STATE OF VERMONT AGENCY OF TRANSPORTATION

PROPOSED IMPROVEMENT BRIDGE PROJECT

MARLBORO
BRF 010-1 (43)

RECORD PLANS	
CONTRACTOR:	RENAUD BROTHERS, INC. - VERNON, VT
RESIDENT ENGINEER:	RON LEMAIRE
CONSTRUCTION BEGAN:	APRIL 8, 2014
CONSTRUCTION COMPLETE:	NOVEMBER 6, 2014
RECORD PLANS BY:	RON LEMAIRE & JENNA HYDE
I HEREBY CERTIFY THAT ALL THE CONSTRUCTION REQUIRED BY THIS SET OF DRAWINGS HAS BEEN ACCOMPLISHED AS INDICATED HEREIN.	
BY	RESIDENT ENGINEER
DATE	02/11/2016
NOTE: Any further information concerning final quantities, amounts or other details relative to this project may be found at Central Files in the electronic archives.

PROJECT NAME: MARLBORO	
PROJECT NUMBER: BRF 010-1(43)	
FILE NAME: s10b414xsl.dgn	PLOT DATE: 28-AUG-2013
PROJECT LEADER: K. HIGGINS	DRAWN BY: K. FRIEDLAND
DESIGNED BY: R. KLINEFELTER	CHECKED BY: G. LAROCHE
MAINLINE SECTIONS 3	SHEET 43 OF 50

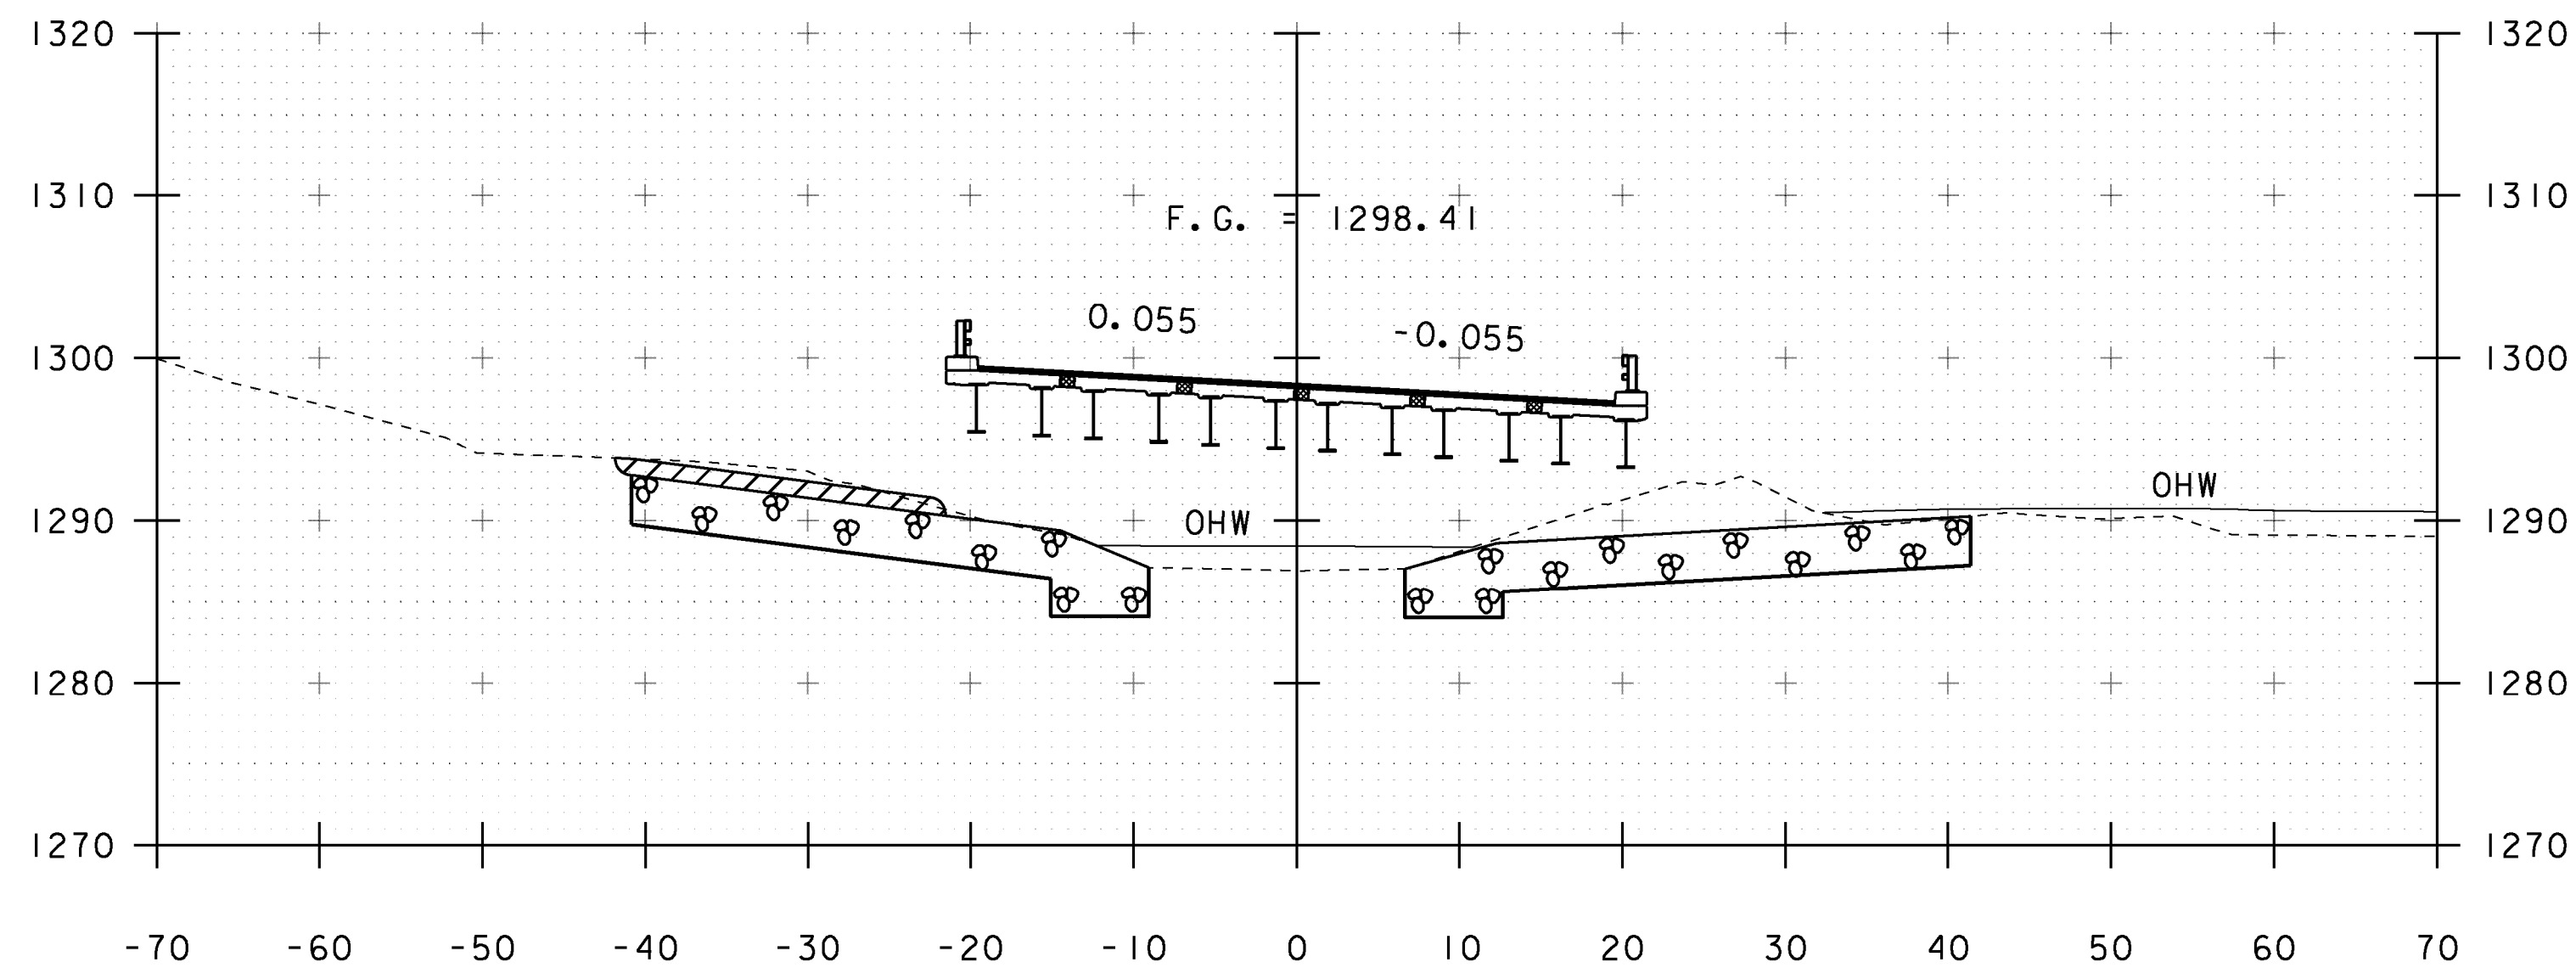
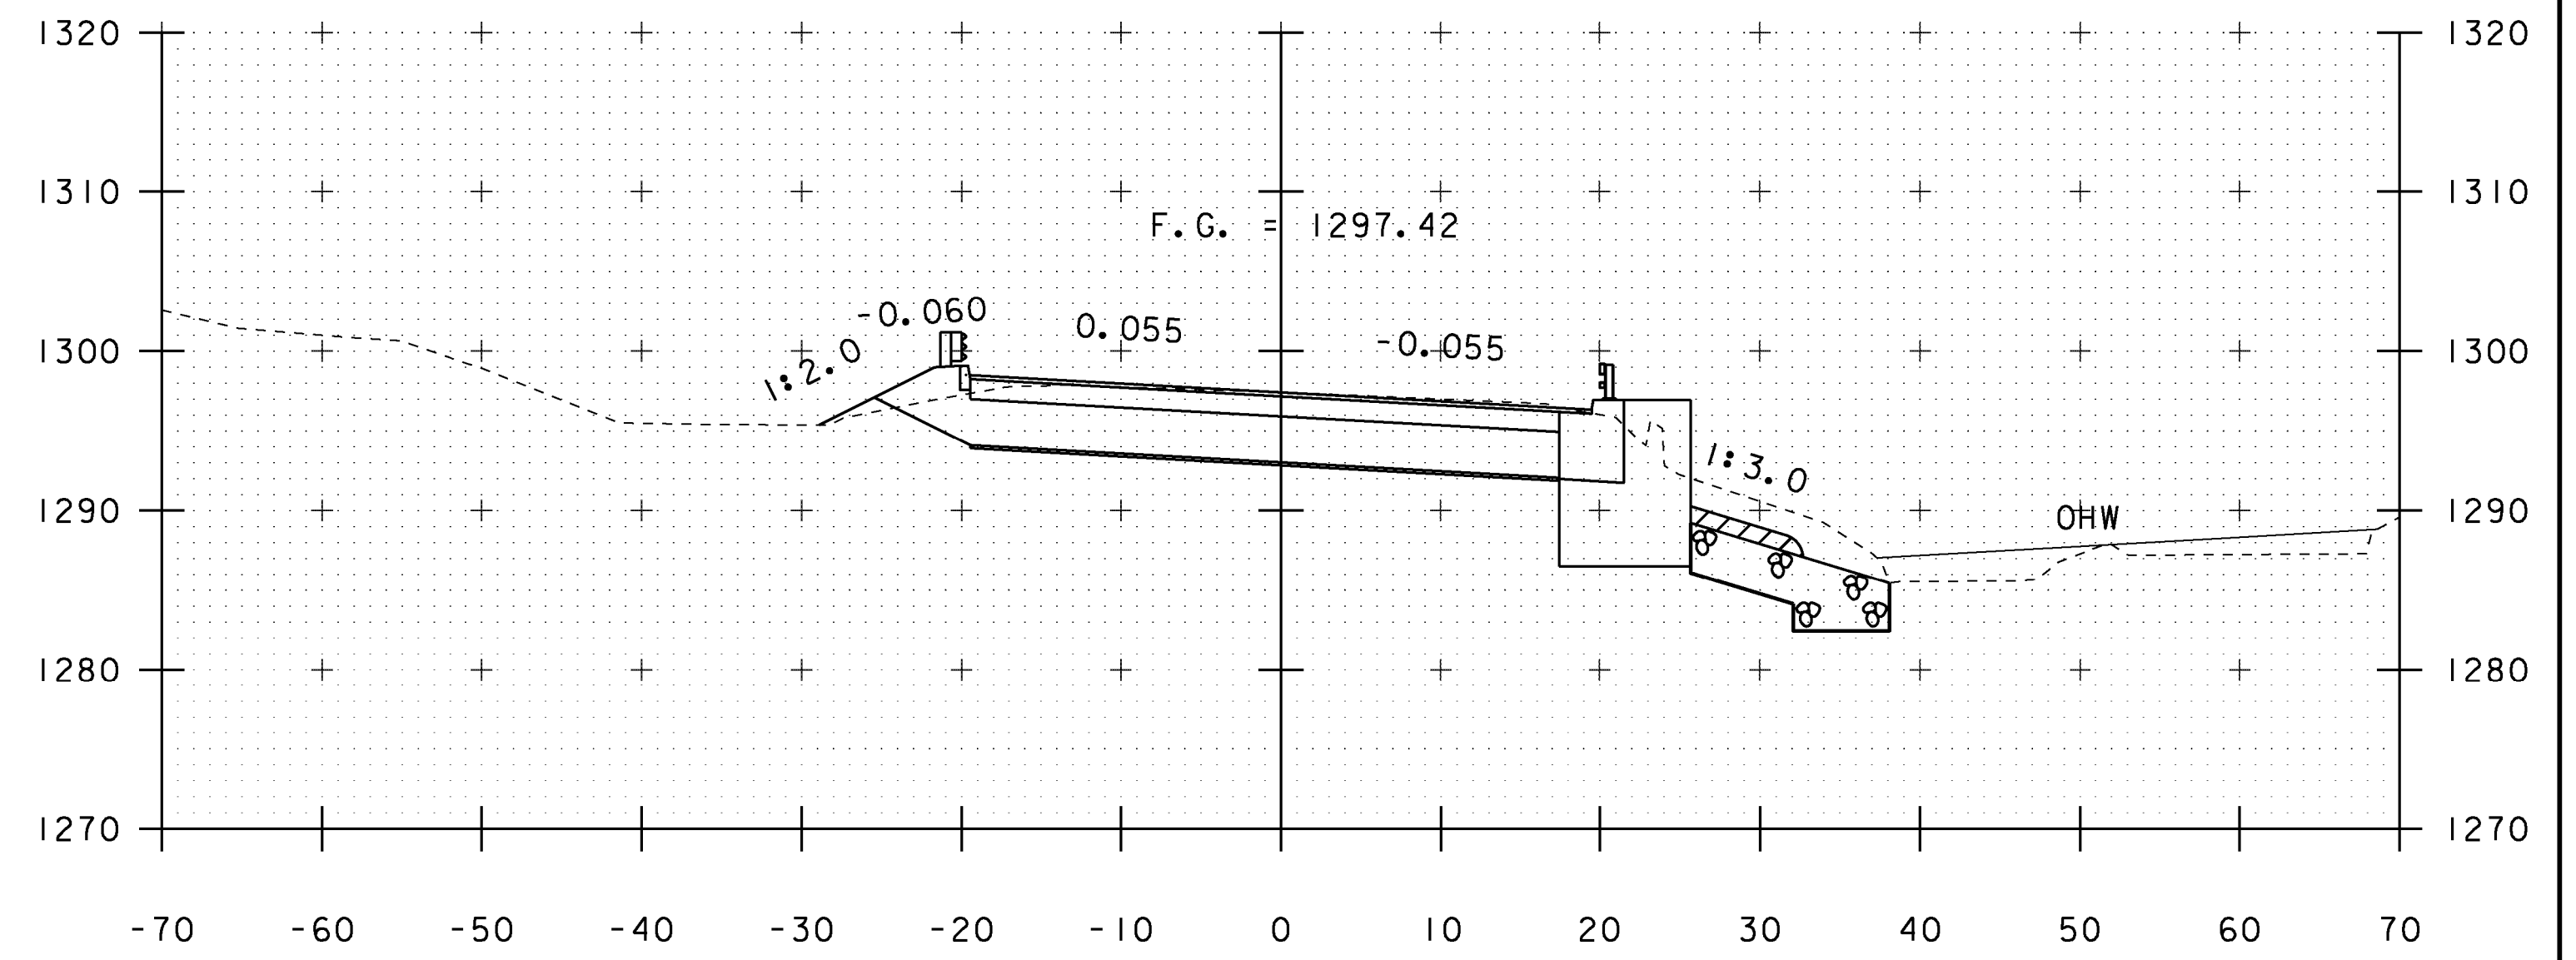
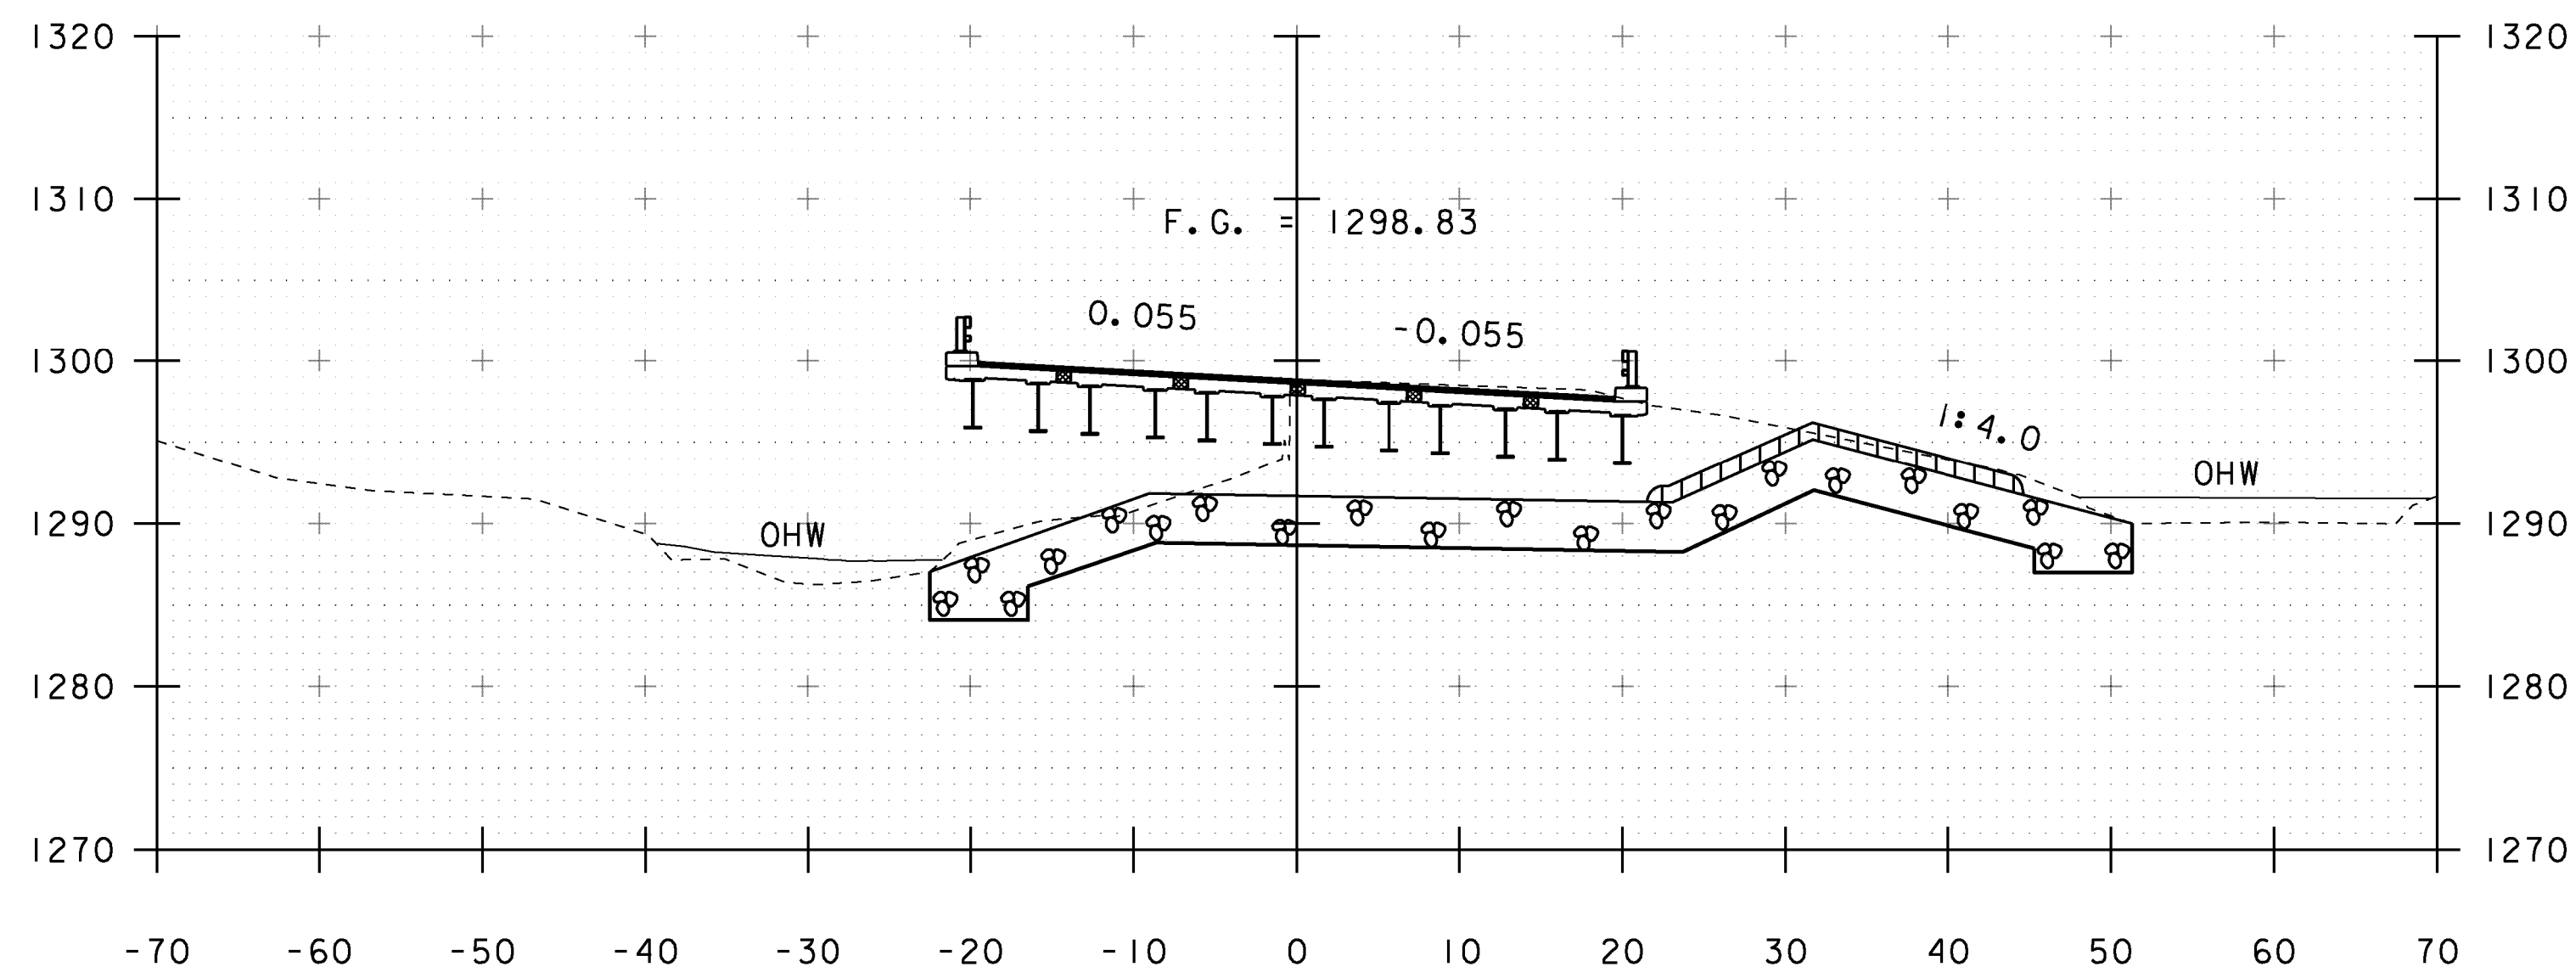
393+50 • REVISED BRIDGE HAS 6 GIRDERS

394+00
 END BRIDGE STA ~~393+93.78~~
 393+93.87

393+25
 BEGIN BRIDGE STA ~~393+12.23~~
 393+12.14
